**MONTGOMERY COUNTY HISTORIC PRESERVATION COMMISSION**  
**STAFF REPORT**

<b>Address:</b>	7214 Spruce Avenue, Takoma Park	<b>Meeting Date:</b>	4/12/2023
<b>Resource:</b>	Contributing Resource <b>Takoma Park Historic District</b>	<b>Report Date:</b>	4/5/2023
<b>Applicant:</b>	Ryan Doyle (Agent)	<b>Public Notice:</b>	3/29/2023
<b>Review:</b>	HAWP	<b>Tax Credit:</b>	N/A
<b>Permit Number:</b>	1021913	<b>Staff:</b>	John Liebertz
<b>PROPOSAL:</b>	Solar panel installation.

**STAFF RECOMMENDATION**

**Figure 5: Solar panel layout submitted by the applicant. The green square shows the proposed location of the seventeen (17) panels on the southern slope of the historic house. Source: Solar Energy World.**

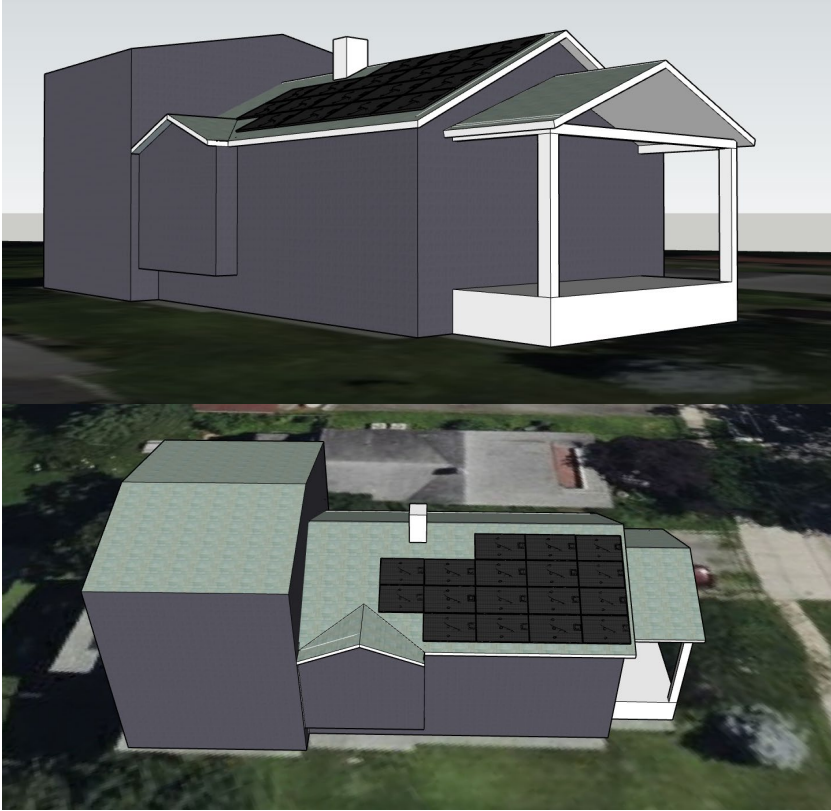
arranged in an organized configuration and avoid disjointed or multi-roof solutions. While the proposed array on the southern slope of the historic house has a low-profile, is consistent with the slope of the roof, and arranged in an organized configuration, the array is setback just 6-inches from the rake (edge) of the roof on the east elevation (façade) and to the valley created by the square bay on the south (side) elevation (Figure 5).

Staff finds that the proximity of the panels to these roof elements to be inconsistent with the installation guidance noted in *Policy Guidance #20-01: Solar Technology (2021)*. In order preserve the character defining form and design of the house and overall streetscape, staff recommends that the applicant removes three (3) panels from this array. *Figures 6 and 7* show illustrative models of the applicant’s proposed array and staff’s recommended array, respectively. Staff’s recommendation provides greater relief from the roof’s rake and from the gable bay, is compatible with the house and overall character of the historic district, and complies with the installation guidance noted in *Policy Guidance #20-01: Solar Technology (2021)*.

Staff recommends approval of the proposal on the condition that three (3) of the seventeen (17) panels are removed from the southern slope of the historic section of the front-gable house.

1. The final set of drawings shall show the removal of three solar panels from the southern slope of the front-gable roof on the original one-story house for a total of thirty-two (32) panels. The solar panels shall be further setback from the rake (edge) of the roof as illustrated in staff's model on page 8, *Figure 7*, of the staff report.
2. Approval of up to sixteen (16) solar panels on the northern slope of the two-story addition is hereby delegated to staff if the applicant submits a revision to this HAWP or a separate HAWP.

### Monthly Consumption and Production (kWh)

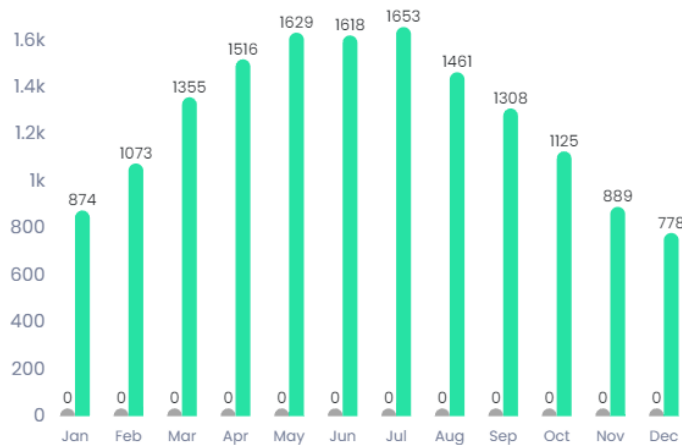
- **Explain how many solar panels are required to support the home vs. how many are there to sell power back to the grid.**

- The home had an annual usage of roughly 13,670 kWh in 2022. Our proposed system is estimated to have 15,281 kWh in annual production.

The panels will vary in production based on their location on the structure, but this estimated production for a 35-panel system breaks down to roughly 437 kWh per panel annually. The system production estimate of 15,281 kWh is 1611 kWh larger than the consumption for the household. This means that a 31 or 32 panel system (depending on the placement of the panels) would be enough to support the household's current rate of energy consumption.

To state as asked – 31 or 32 panels are required to support the home while the remaining 3 or 4 panels are there to slightly oversize the system.

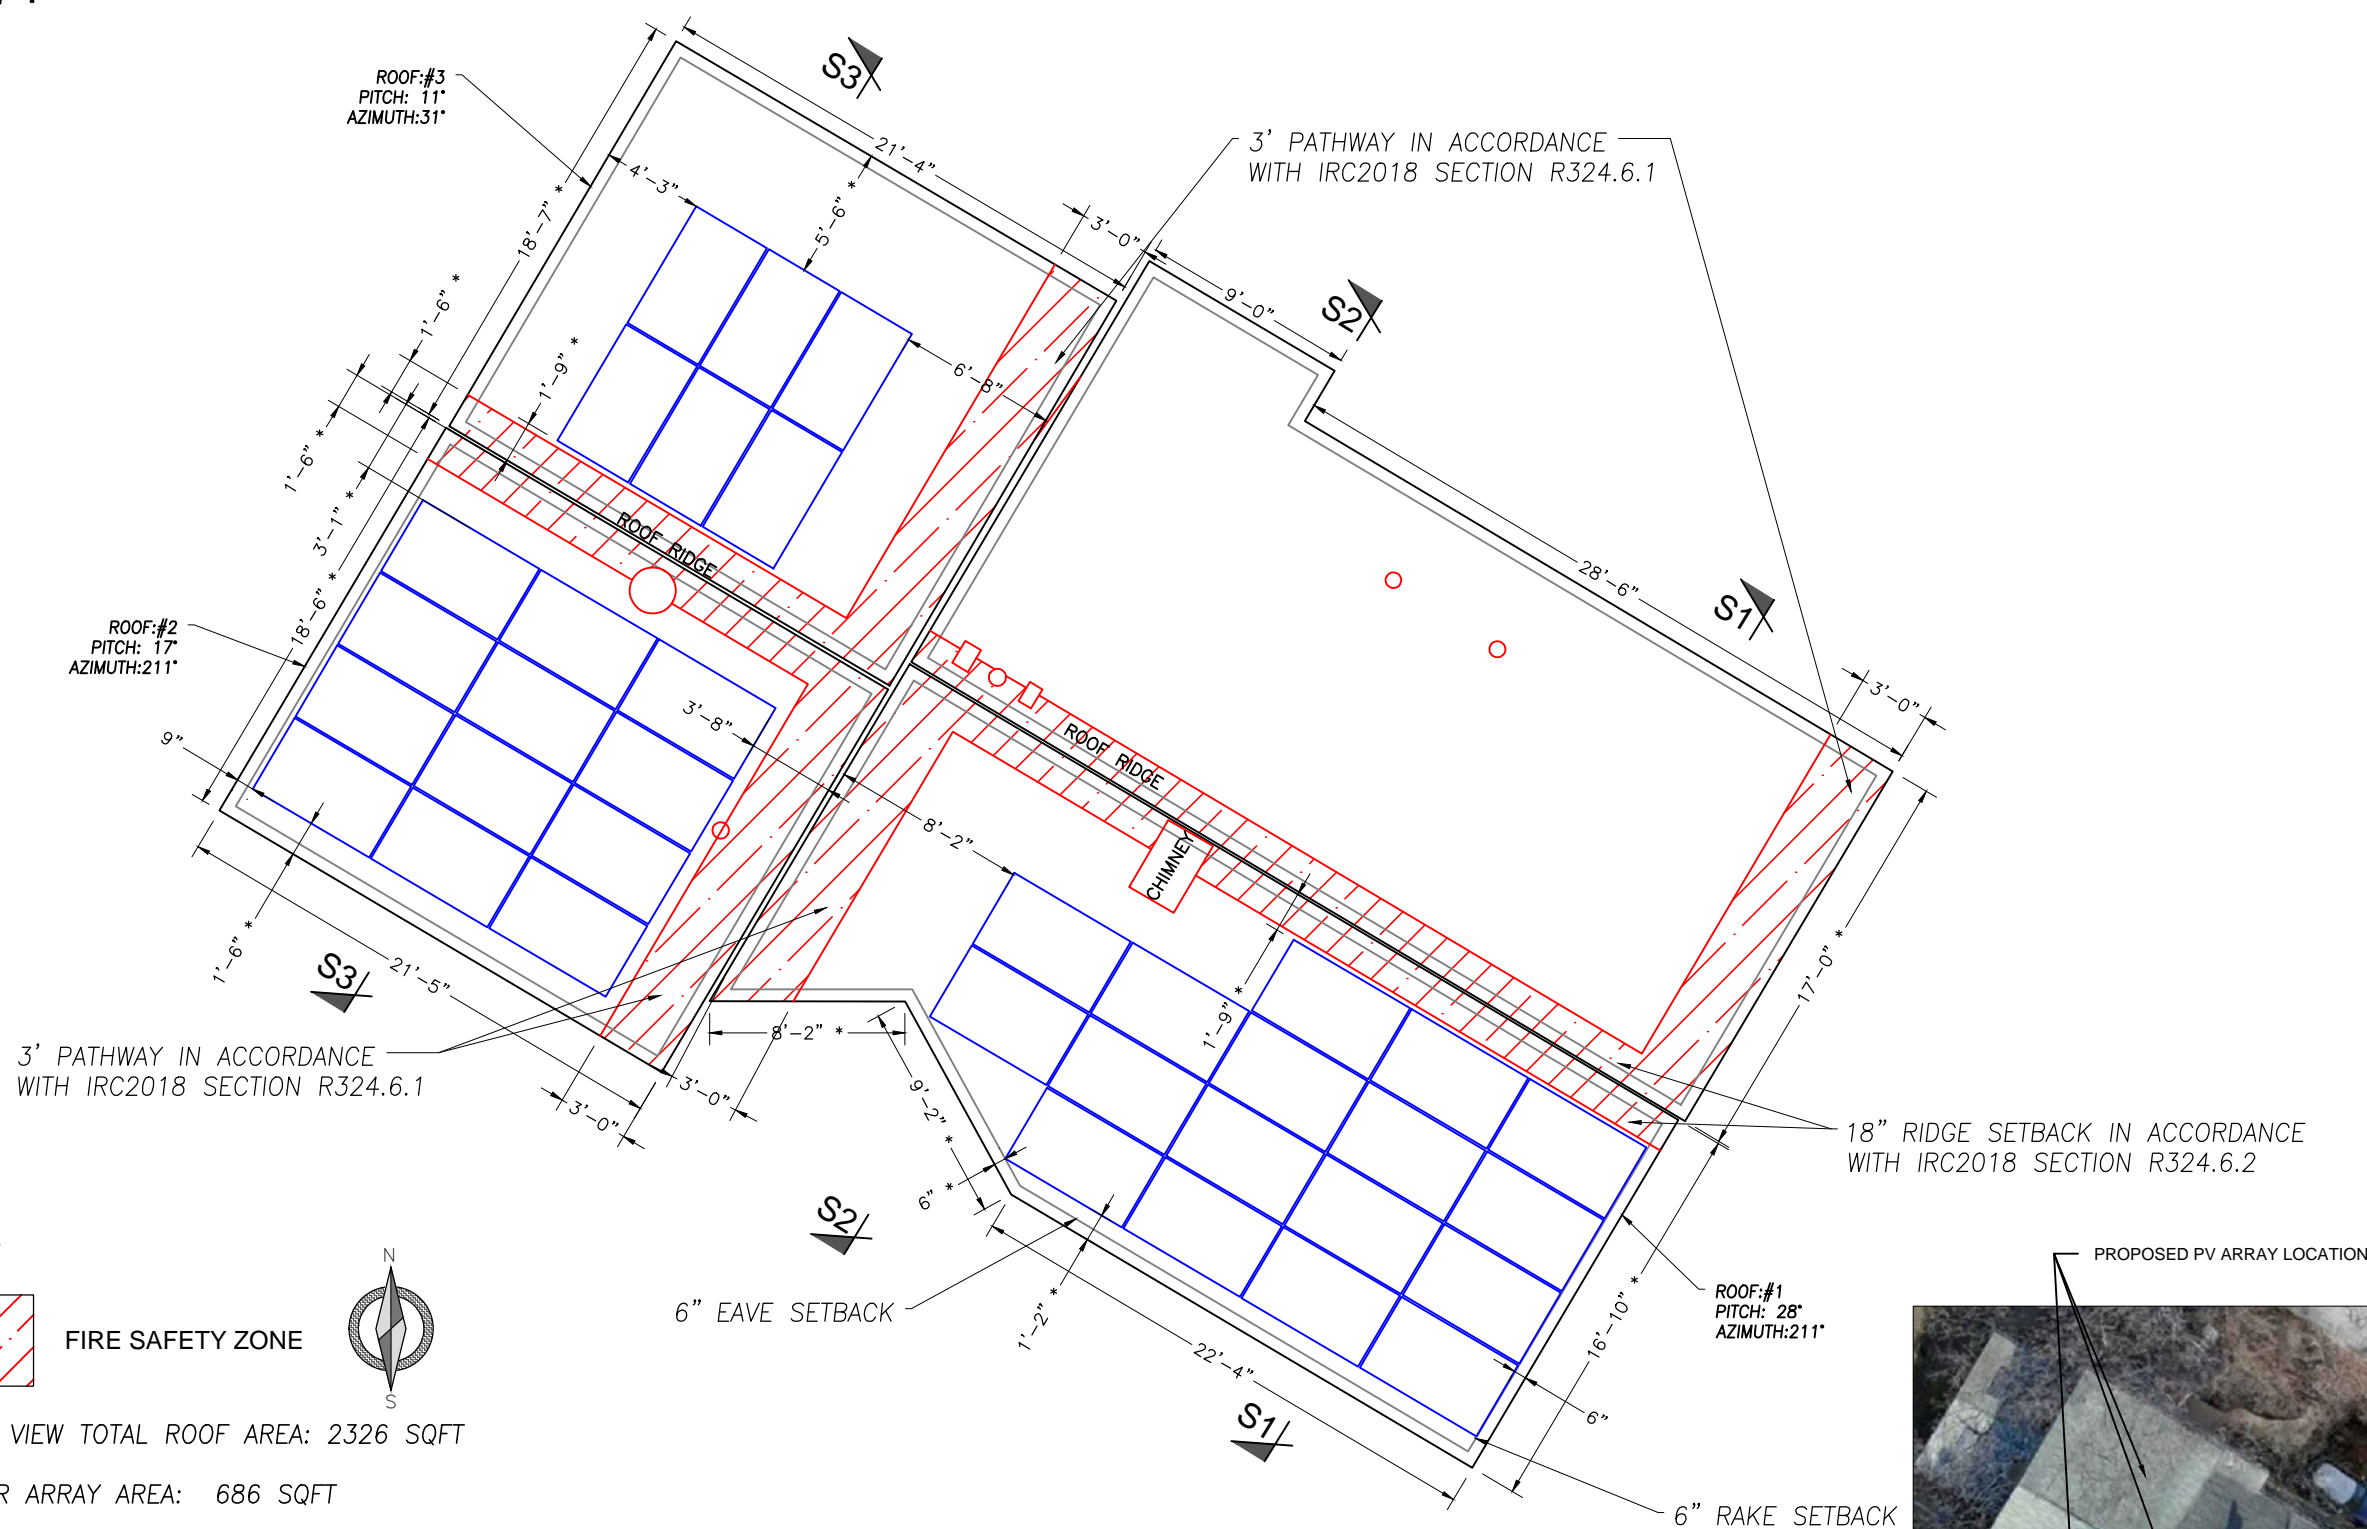
- **Include a written justification on the 35 panels and the location of the panels. For example, why are there not more panels on the north elevation (where there are six on the north slope of the rear gable addition). Why are the panels very close to the front of the house (what is the setback of those panels from the edge of the roof). Can the panels be moved more towards the rear? Could the panels be split between both roof slopes (north and south)?**

- The south facing roof planes are maxed out because these roof planes offer the highest rates of production; this is why 29 of the panels are designed to go on these roof planes.

- Of the two north facing roof planes, the roof of the rear gable addition offered better production than the north facing roof of the main gable. This is due to the roof planes' higher elevation off the ground and flatter pitch.

- As the drawings now indicate, the setback from the rake on the south facing roof plane of the main gable is 6 inches. From a production standpoint the array was pushed as far towards the front of the house in an effort to minimize the impact of the shade from the trees southwest of the house. In the interest of aesthetics and ease of installation, the array of 17 panels was designed in one block of panels, all in the same orientation, while also accounting for the chimney and small dormer on the southwest edge of the roof plane.

- If the array was kept in one block of panels, moving the array further towards the rear would result in a loss of panels as the chimney and dormer would get in the way. If the array were split up and a mixed orientation was chosen, we could keep the same number of panels, however they would be arranged in a much less aesthetic fashion. There would also be a minor drop in production due to the higher shade coverage from the aforementioned trees to the southwest.
